2. Historic District Commission Meeting Packet 10-23-18

CITY OF YPSILANTI
Agenda
Historic District Commission
Tuesday, October 23, 2018 - 7:00 p.m.
City Hall, Council Chambers, 1 S. Huron
Ypsilanti, MI 48197

NEW FLOOR PLANS
101 W. MICHIGAN
101 WEST MICHIGAN AVE., YPSILANTI, MI
SHELTER BAY REALTY LLC
ISSUE
90% CONSTRUCTION DOCUMENTS
REVISION
DRAWN BY CMN
DATE 10/11/2018 6:36:44 AM
SCALE As indicated
STAMP
PROJECT 2018.08
SHEET

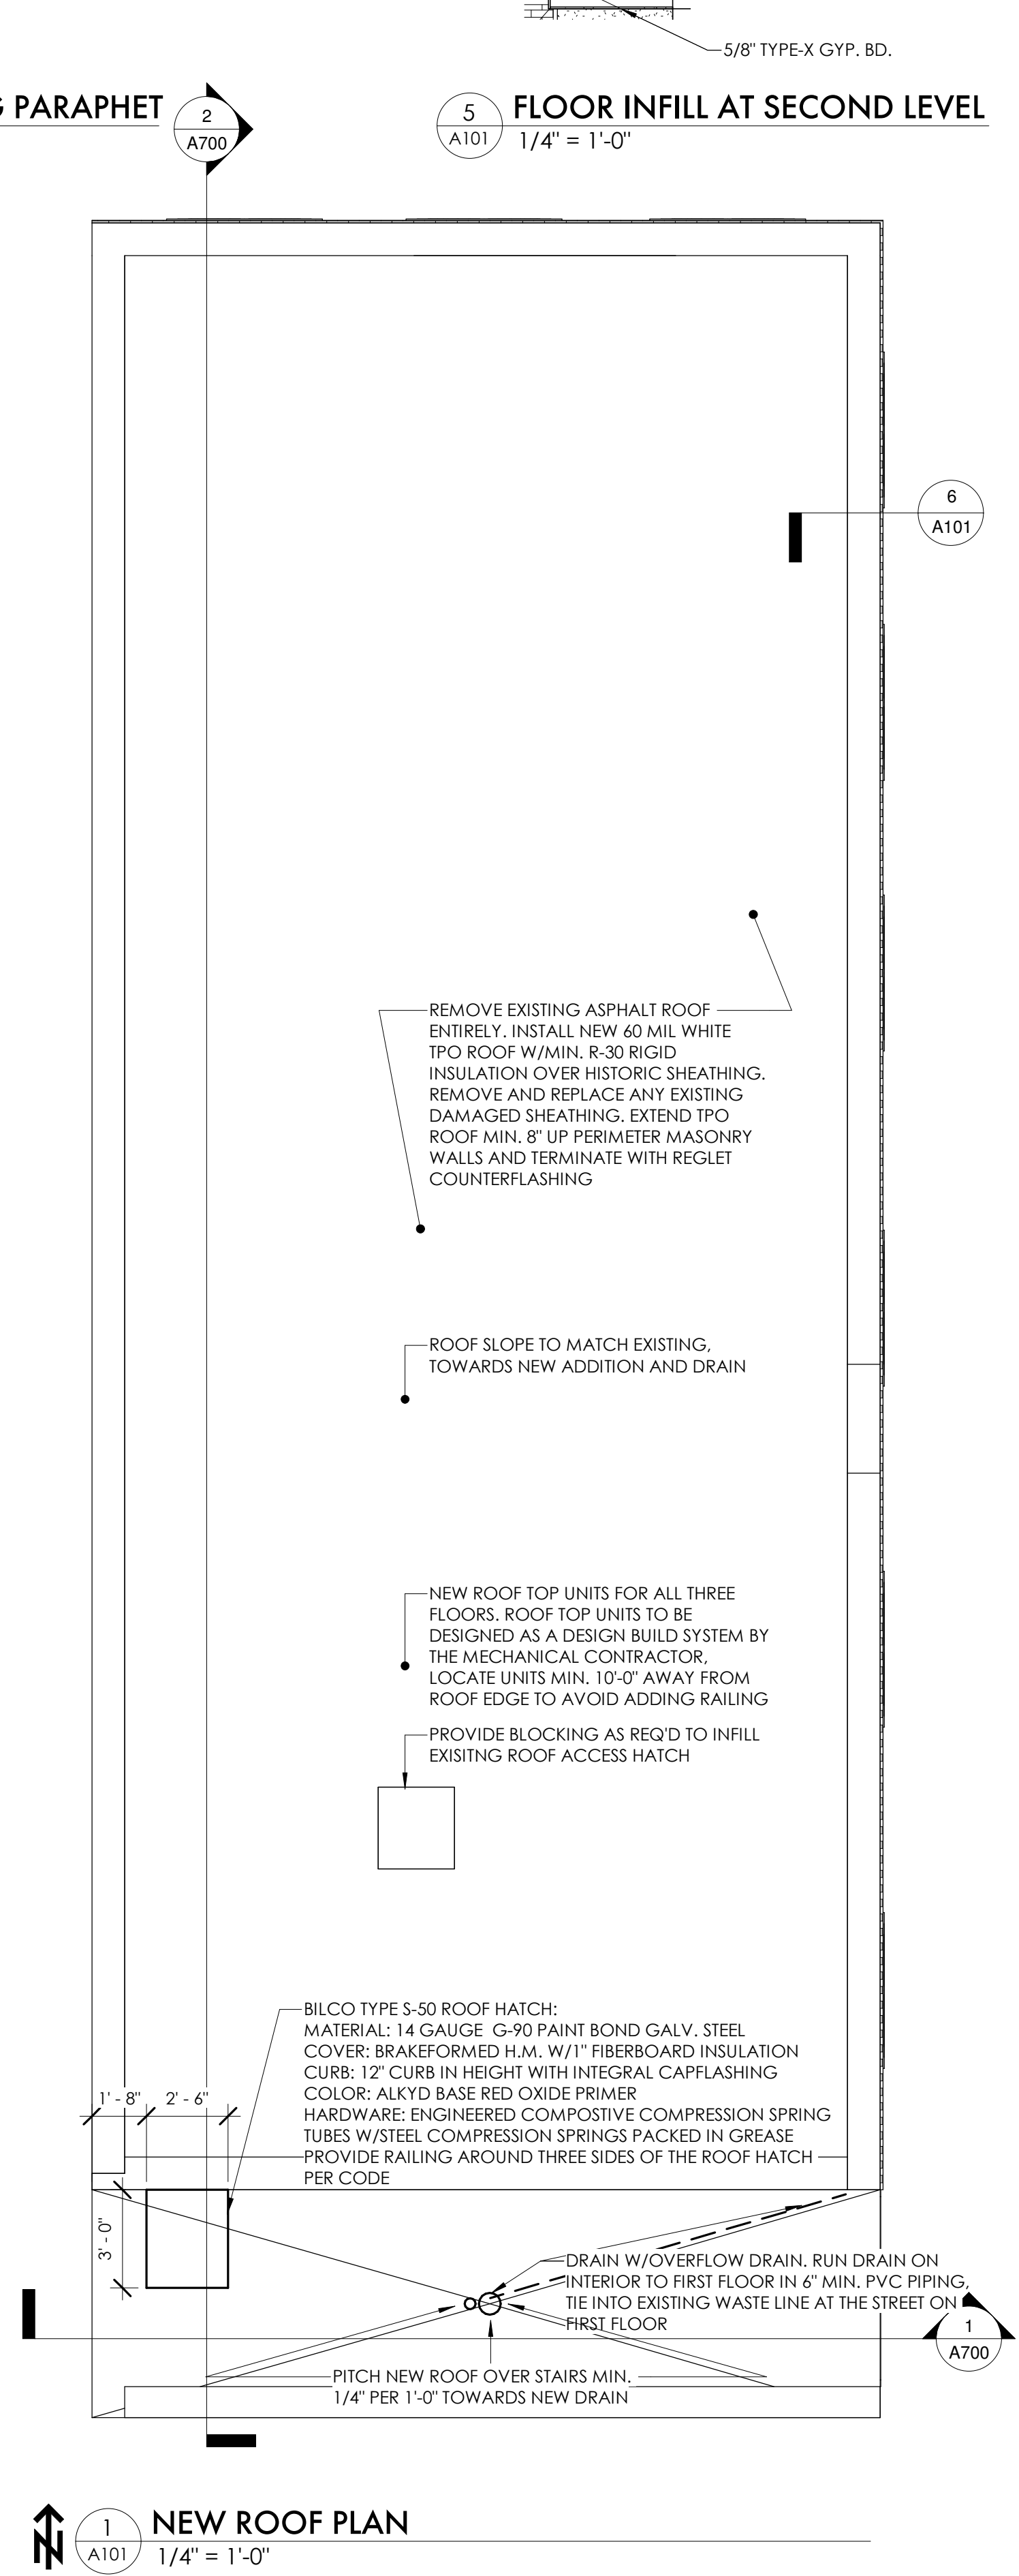
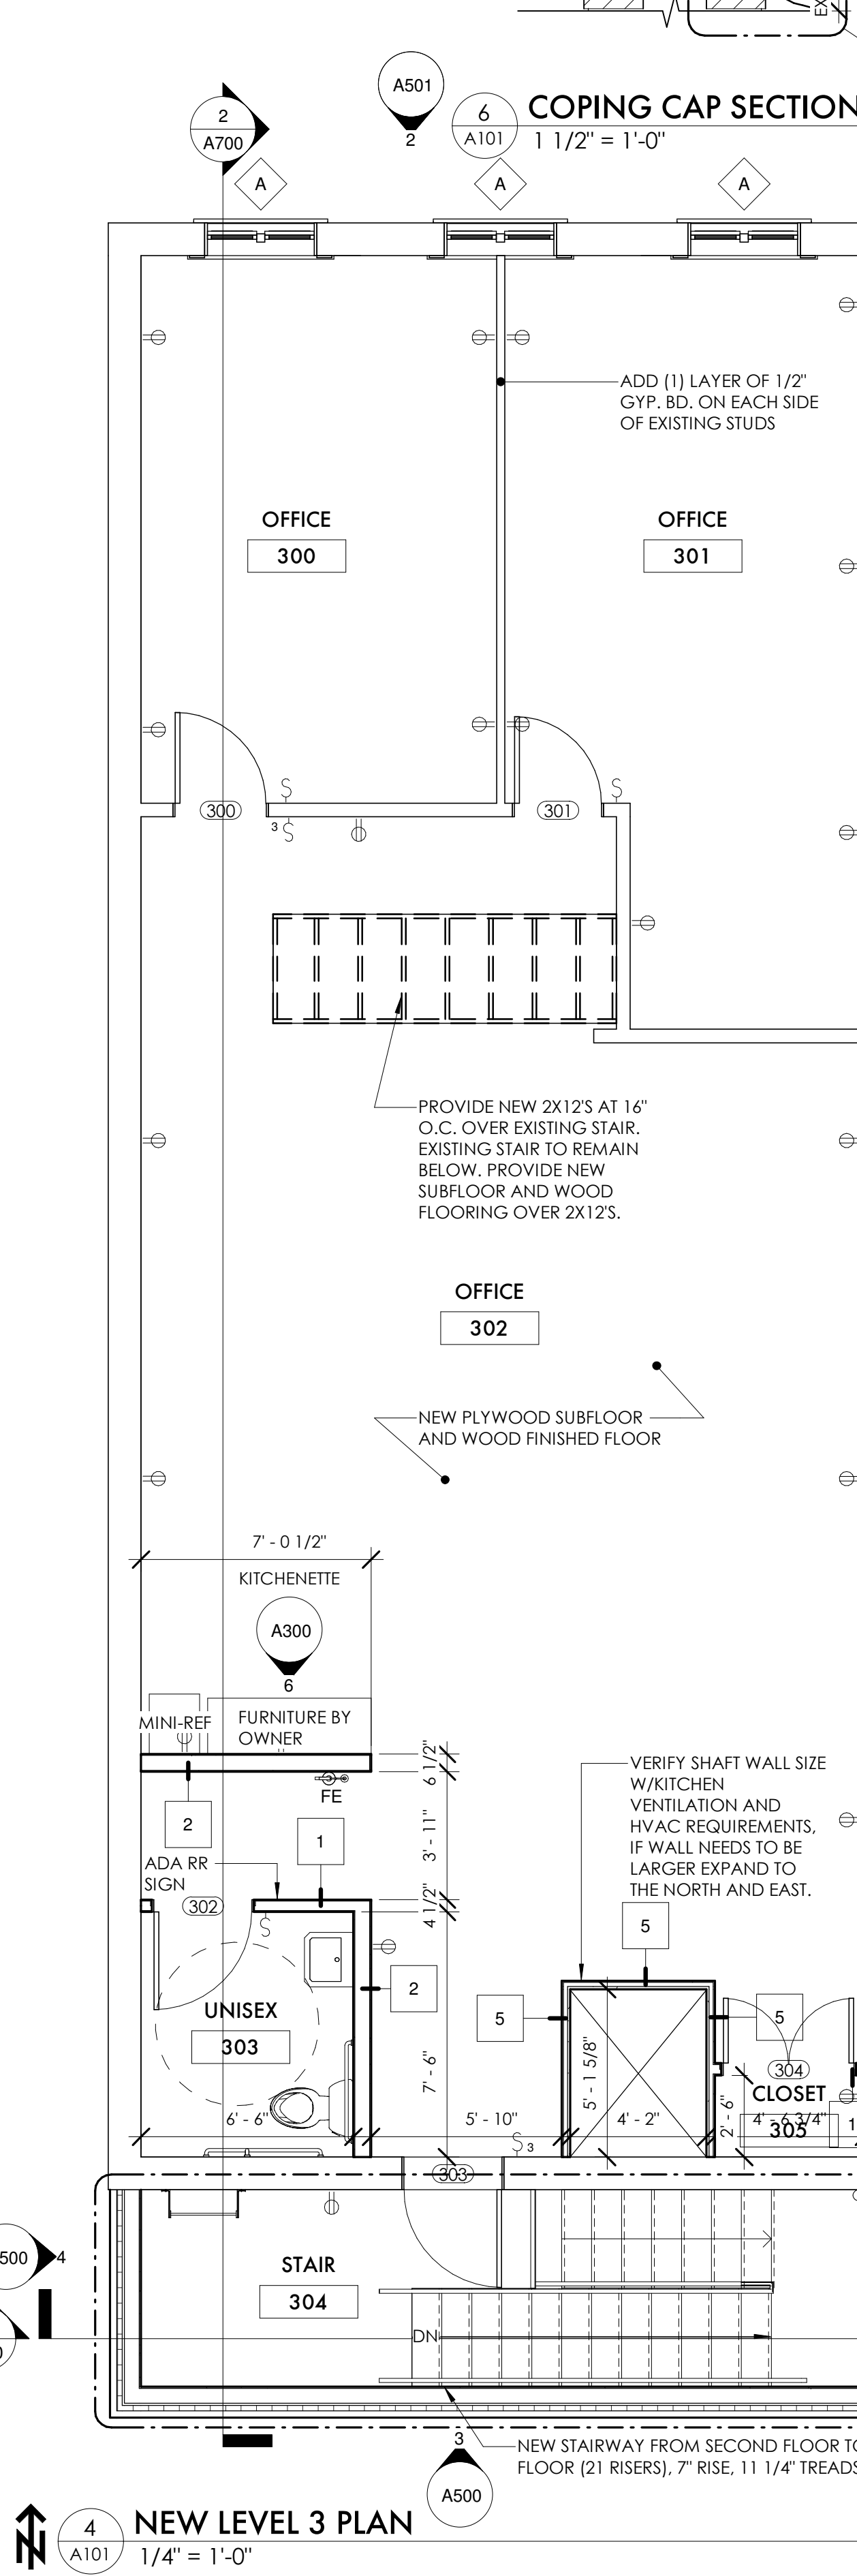
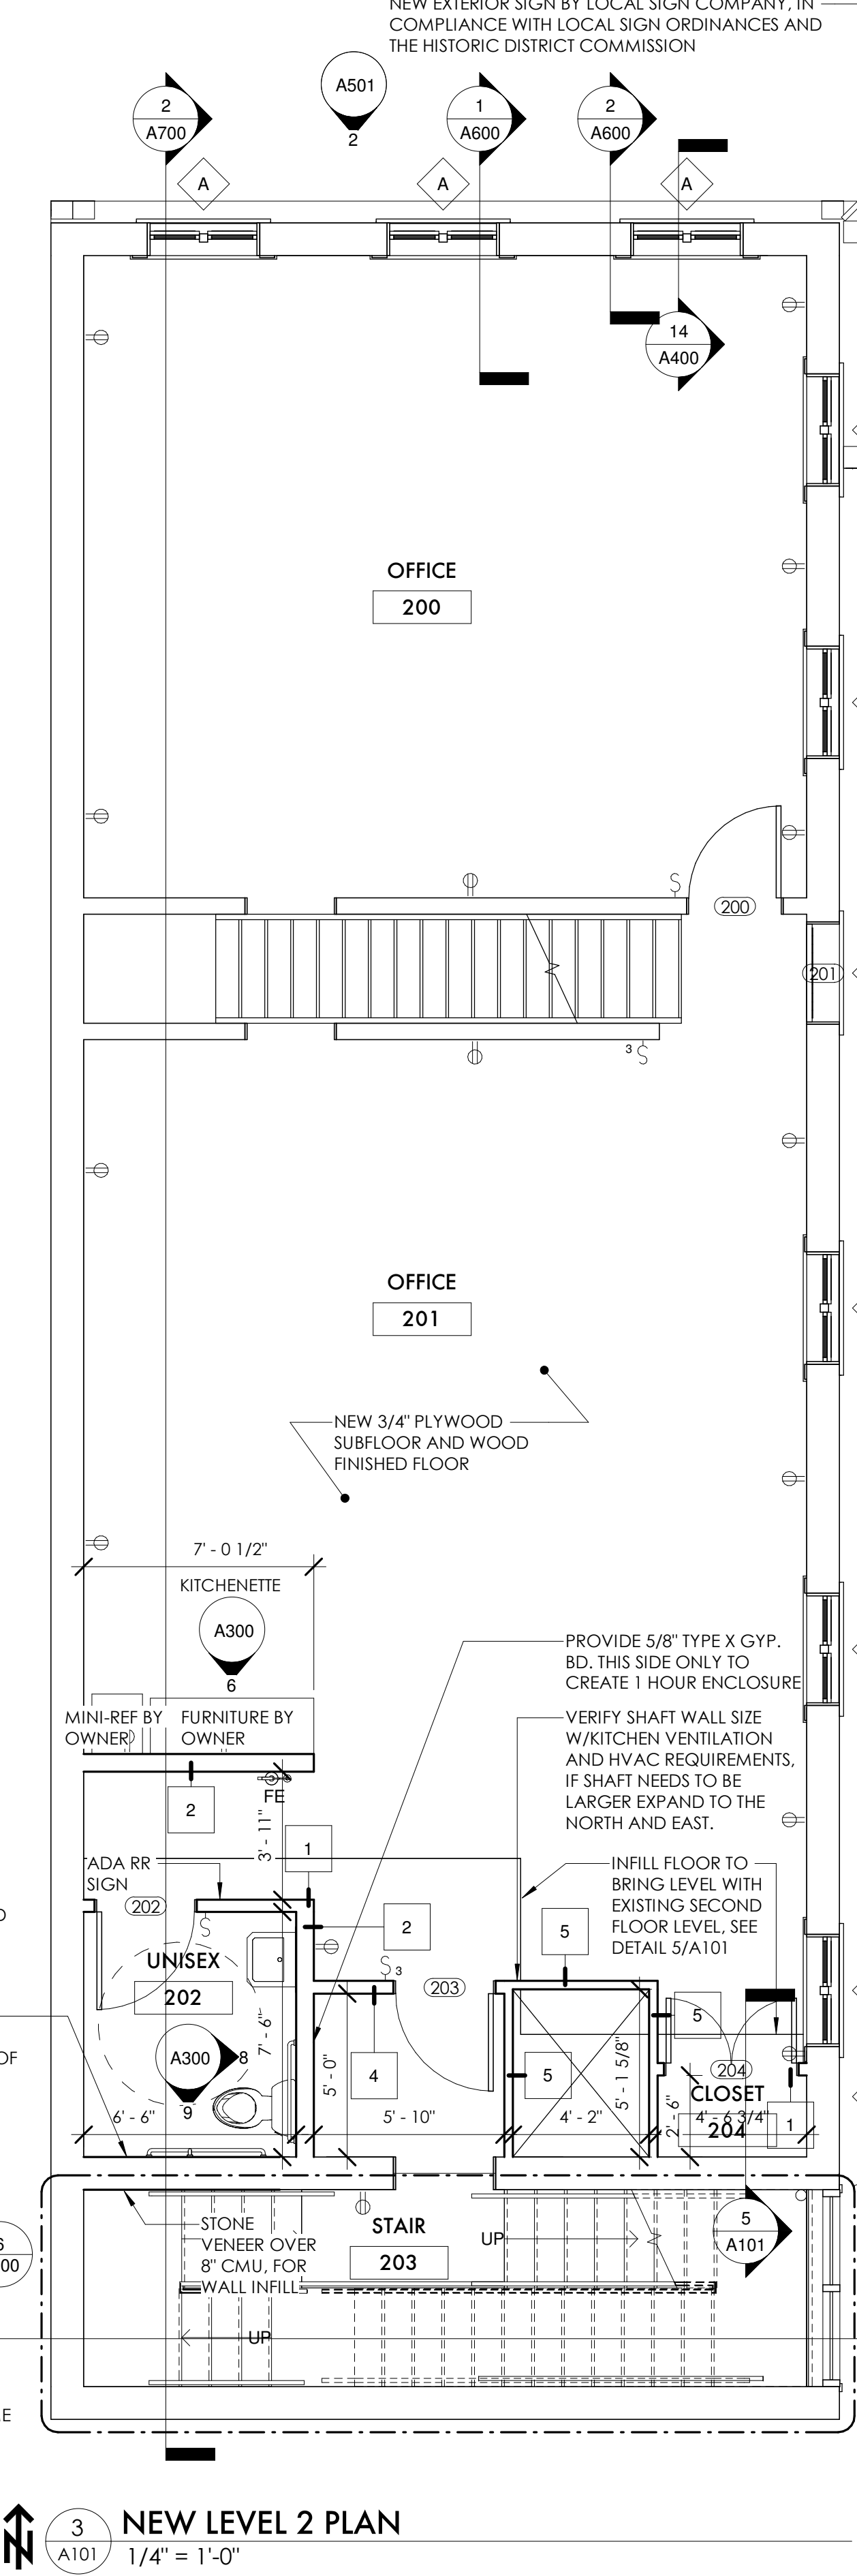
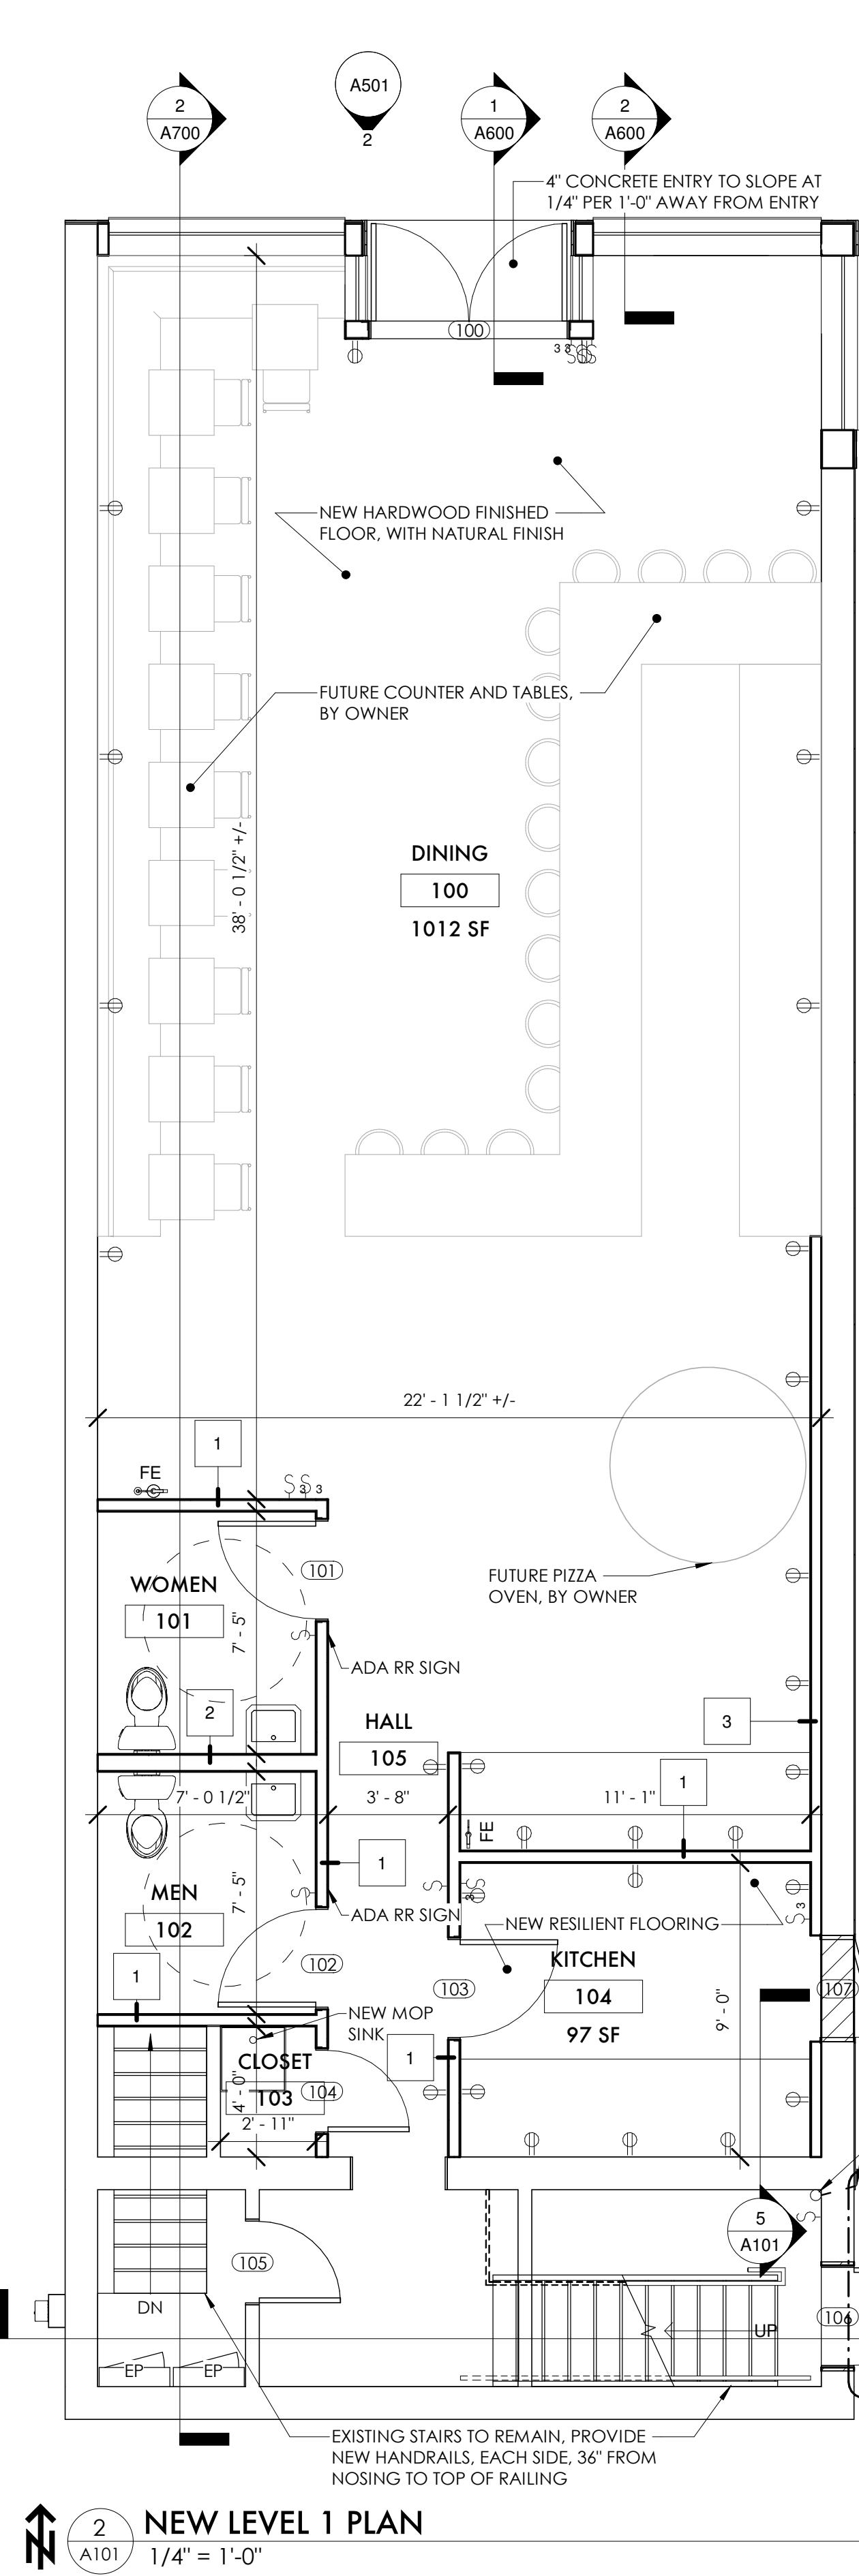
3. The applicant has provided paint colors but not the locations of the paint colors. HDC to verify same.
4. The applicant has offered two options in the storefront renovations. Staff has included historic photos that do not depict either of these storefront options. Staff has requested these images from the applicant.

5. Type K mortar is acceptable per the NPS preservation brief.
6. The Tubelite and finished metal system for the addition is clearly a modern addition.
7. The applicant has proposed metal and wood replacement doors on the east side of the building, the upper level door is not indicated. HDC to verify if that will remain as well as the material for the new storefront doors.

8. It is unclear as to what the orange area on the plans are, HDC to verify if this is a sign board, awning, etc.
9. Staff suggests that lighting and signage be handled separately at a later time.

Move to approve and issue a certificate of appropriateness for work at 101 W Michigan to include the building restoration and rear stair/elevator addition as indicated in the plans dated 10-11-2018 with the conditions that the windows be aluminum clad wood windows and the storefront restoration be completed as indicated in the plan page A500.
